ALLEGHENY COUNTY SANITARY AUTHORITY

CONTRACT NO. 1735 G, E, H, P

ALCOSAN PARKING GARAGE

ADDENDUM NO. 1

210-A-42
STAIR 1 / ELEVATOR - ENLARGED 3RD & 4TH LEVEL PLANS

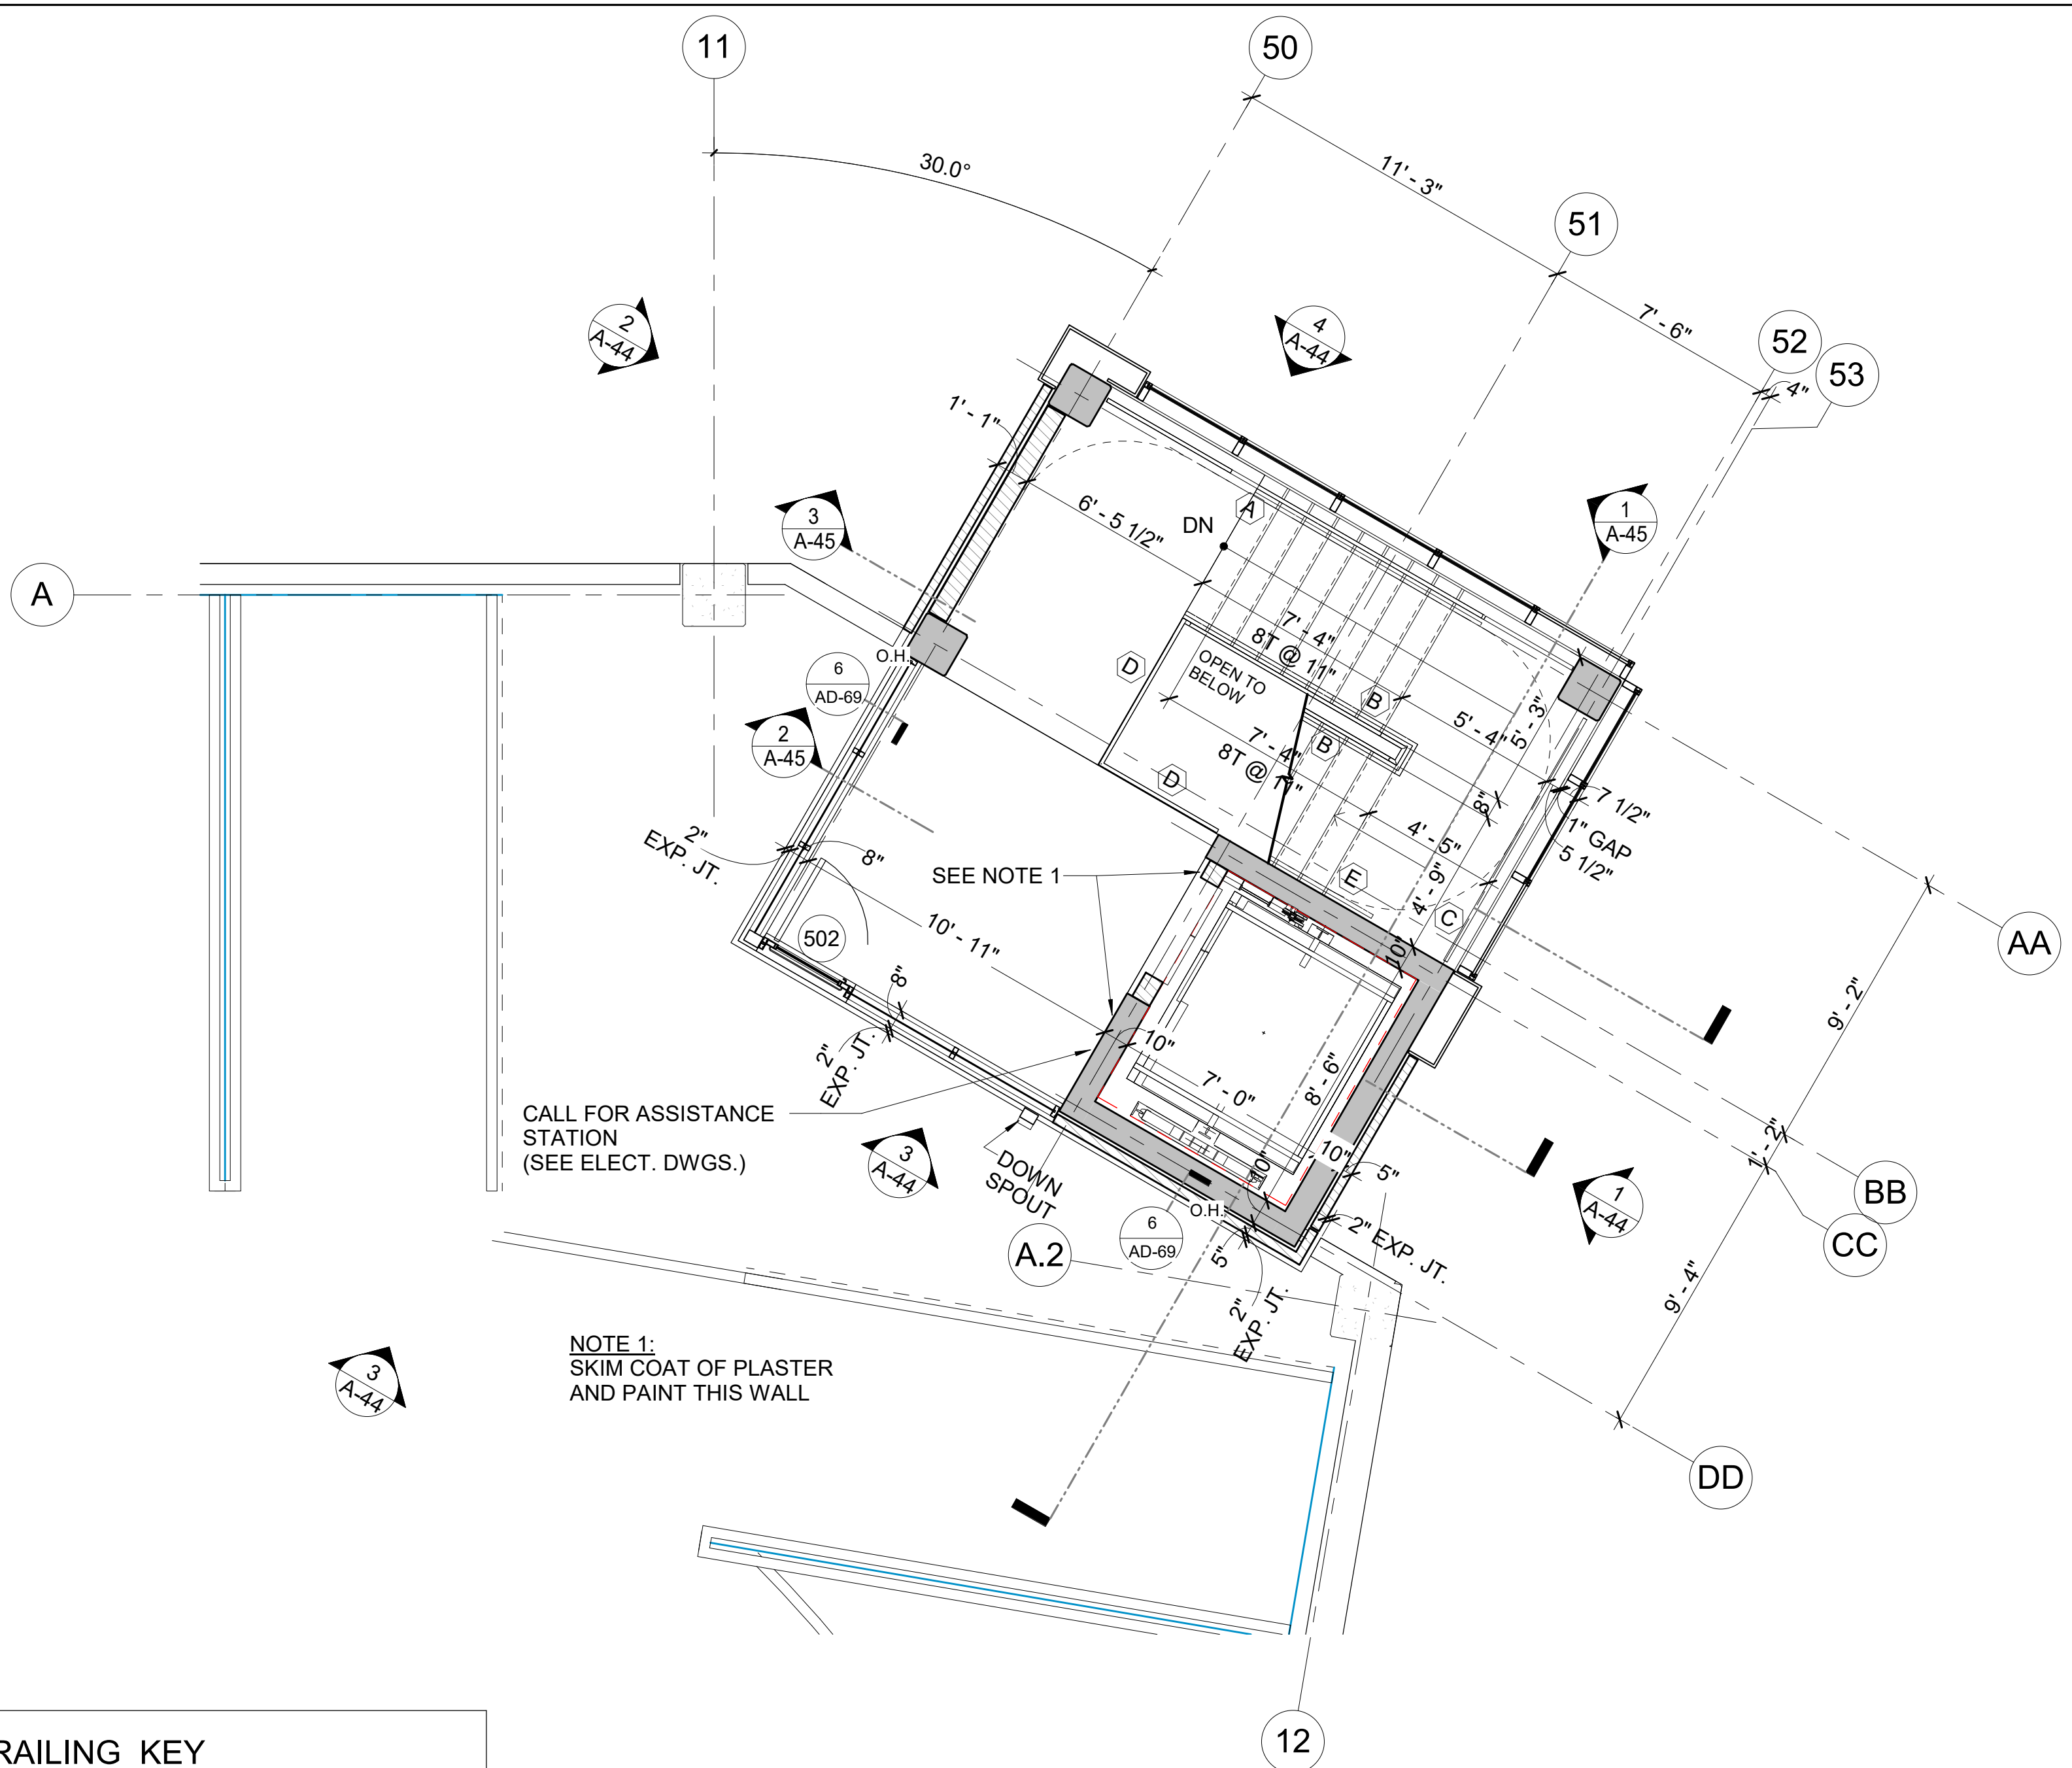
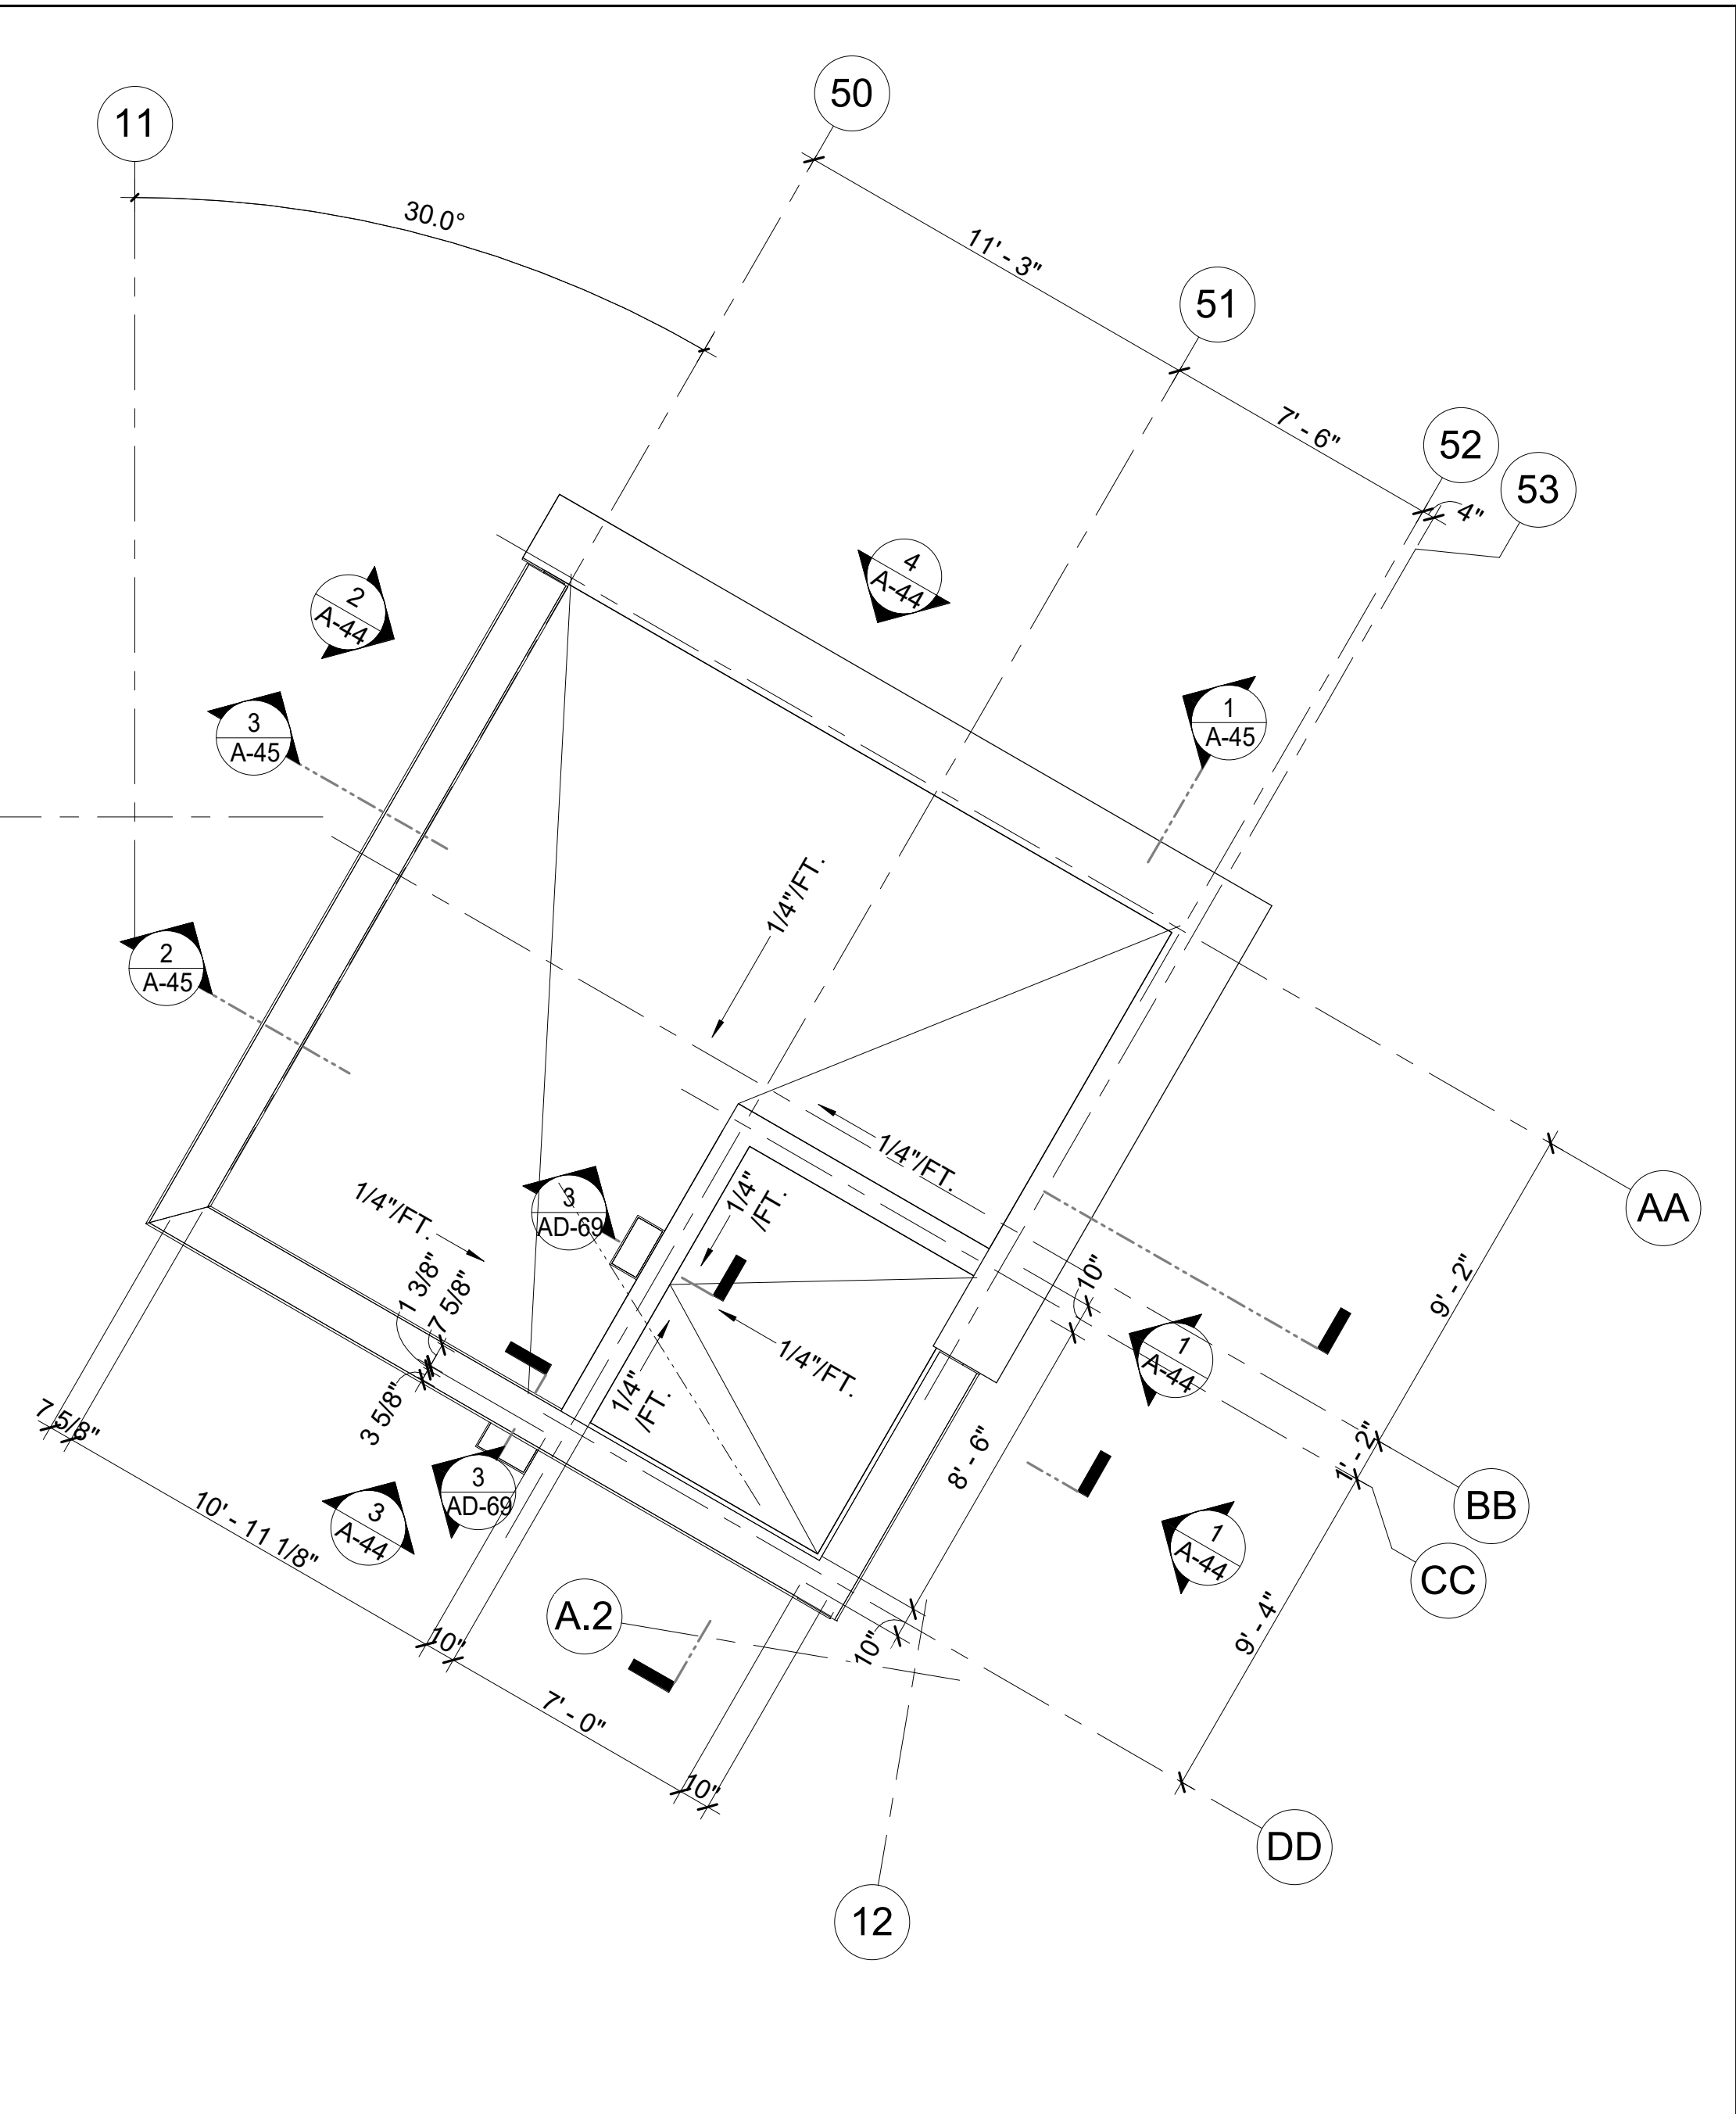
4. Drawing 210-A-42 Stair 1/Elevator – Enlarged 3rd & 4th Level Plans:
 - a. ADD:

Q12: Drawing A-42, Note 1 (for example): Indicates a “skim coat of plaster.” Please provide a specification for this product and please define the limits of this plaster. For example, the note points to surfaces where the details (such as 1 & 3/AD-71) show masonry with no plaster coating.
